Document: T10/01-230r1 Date: 3 August 2001
 To: T10 Committee Membership
 From: Edward A. Gardner, Ophidian Designs
 Subject: SRP Buffer Descriptor Subclause Rewrite

Revision 0 of this document is the affected portions of SRP with change bars from SRP revision 07.

Revision 1 of this document incorporates changes from the July 19-20 SRP working group, including the changes described by 01-230 (SRP Buffer Descriptor Formats).

Figure 3 - Example indirect data buffer descriptor with no PARTIAL MEMORY DESCRIPTOR LIST field

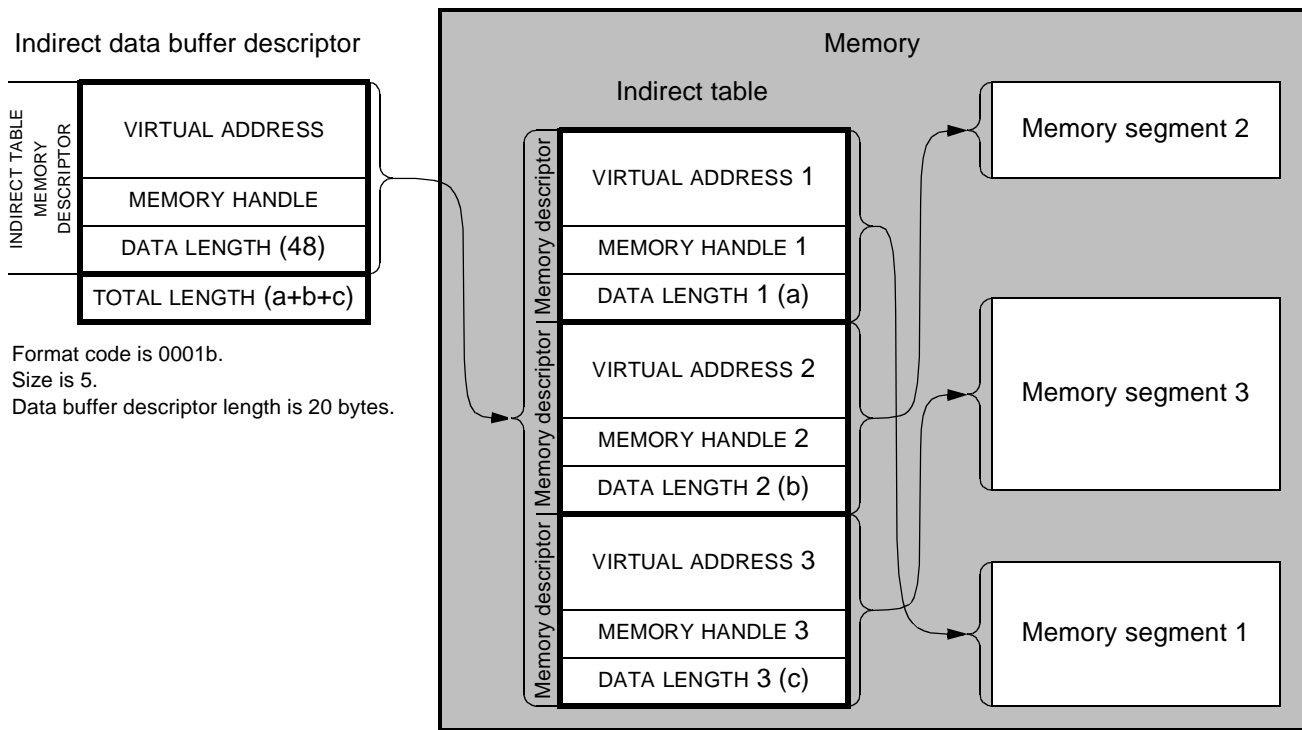
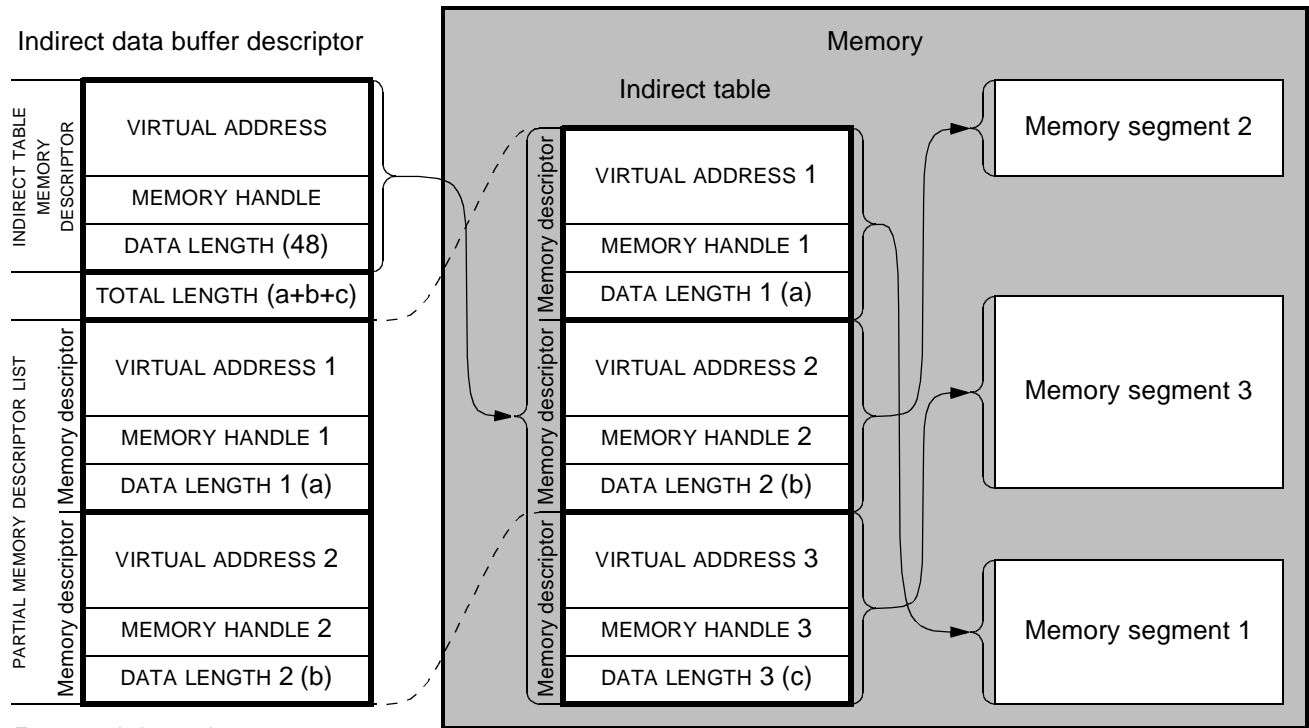
Figure 3 illustrates an indirect data buffer descriptor that does not contain a PARTIAL MEMORY DESCRIPTOR LIST field. Memory is shown containing four memory segments: the indirect table, memory segment 1, memory segment 2 and memory segment 3. The mapping of each memory descriptor to its memory segment has been shown as a single arrow. For details of this mapping see 4.4.1 and figure 2. Figure 3 does not show the memory regions in which the memory segments reside. All four segments might be in a single memory region, each

In the example shown in figure 3 the data buffer descriptor format code is 0001b and the size is 5. The indirect data buffer descriptor is 20 bytes long. The data buffer is comprised of three memory segments: memory segment 1, memory segment 2 and memory segment 3. A separate memory segment contains the indirect table, a list of three memory descriptors specifying memory segments 1 through 3. The INDIRECT TABLE MEMORY DESCRIPTOR field value of the indirect data buffer descriptor specifies the memory segment containing the indirect table. The DATA LENGTH field of the INDIRECT TABLE MEMORY DESCRIPTOR field value contains 48 (i.e. the length of the indirect table). The TOTAL LENGTH field of the data buffer descriptor contains the sum of the DATA LENGTH field values of the memory descriptors in the indirect table (i.e. the sum of DATA LENGTH 1, DATA LENGTH 2 and DATA LENGTH 3). This sum is the total length of the data buffer.
